Reference: 0468089

**Subject: Grocon Group Ribbon Development Response**

ERM has been engaged by Grocon to provide a brief letter detailing a review of the proposed monitoring system and a response to the Road and Maritime Services (RMS) information request (dated 13 March 2019 - document reference SYD15/01513/13) and the Department of Planning & Environment (DPE) information request (Dated 15 March 2019 – document reference SSD 7388 MOD 7).

**Figure 3.1: NO<sub>2</sub> Analyser Equipment Location on Level 23**

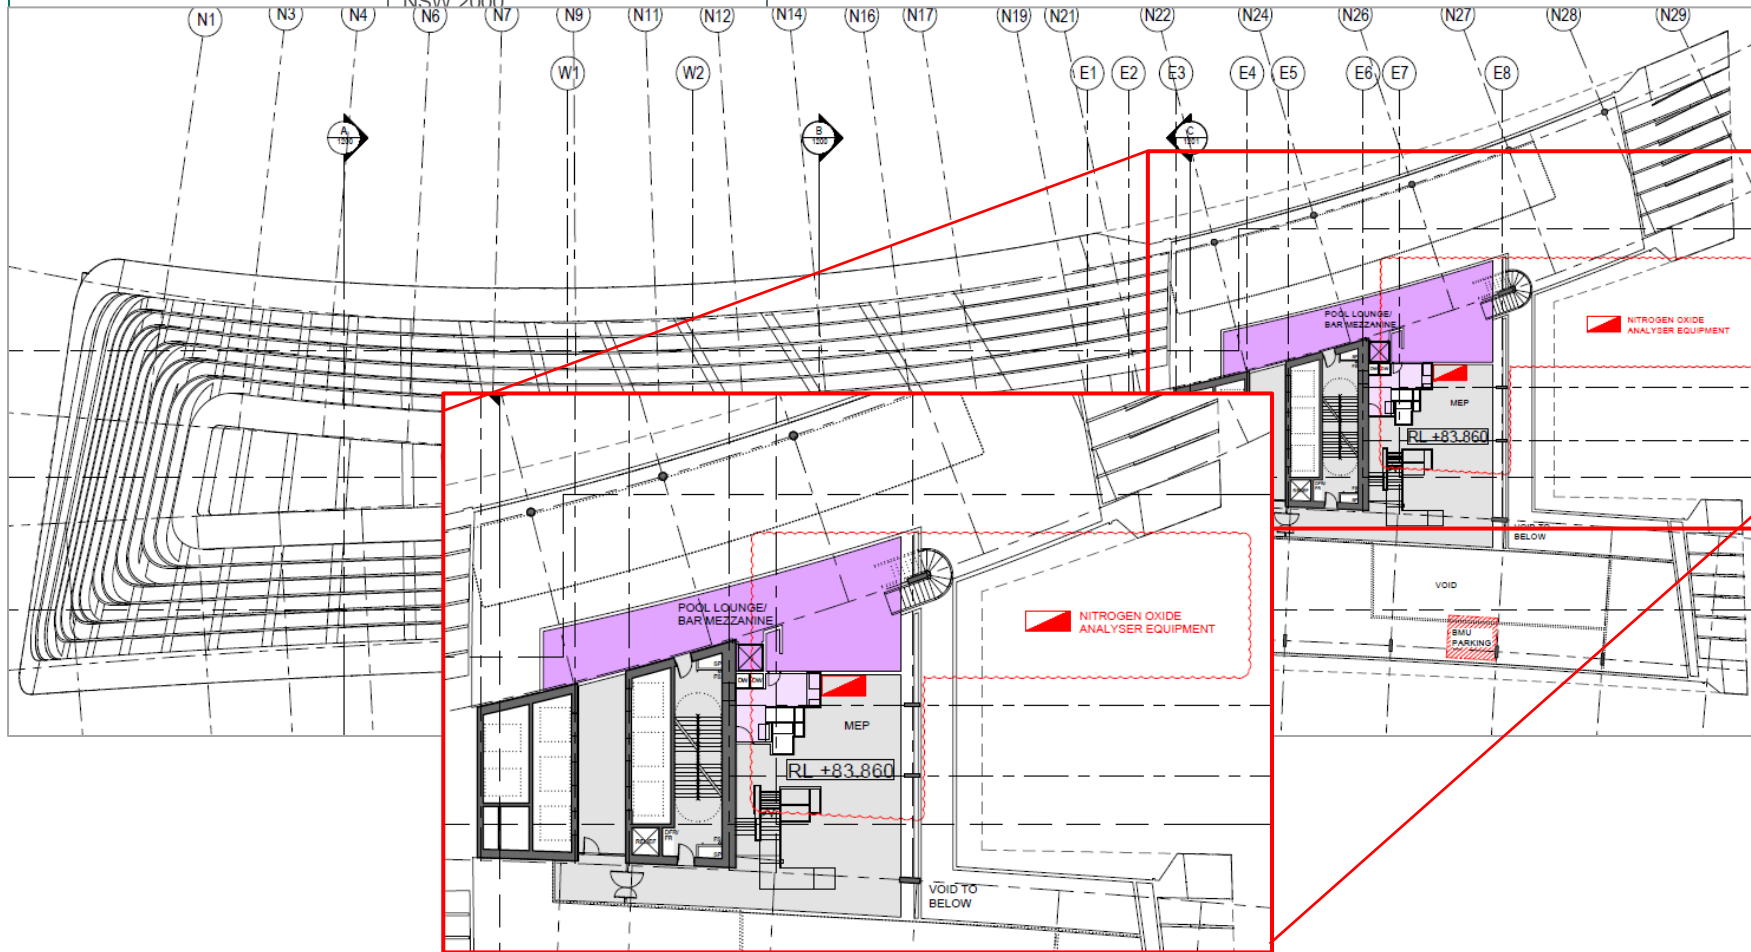
The proposed location of the NO<sub>2</sub> analyser equipment on Level 23 and the NO<sub>2</sub> sensor tube locations on Level 22 are presented in **Figure 3.1** and **Figure 3.2**.

Please note that these figures should read nitrogen dioxide analyser and nitrogen dioxide sample inlets as opposed to 'sensor tubes'.

**Figure 3.2** shows four sample inlets spaced around the pool deck area. Following discussions with the equipment provider, Lear Siegler, it is anticipated that all sample inlets will draw air to a central sampling manifold within the plant room (refer **Figure 3.1**).

Please see Section 3 of this document for the proposed locations of the NO<sub>2</sub> sample inlets (NB: not sensors). The sample inlets will be located on the underside of the open roofing on Level 23.
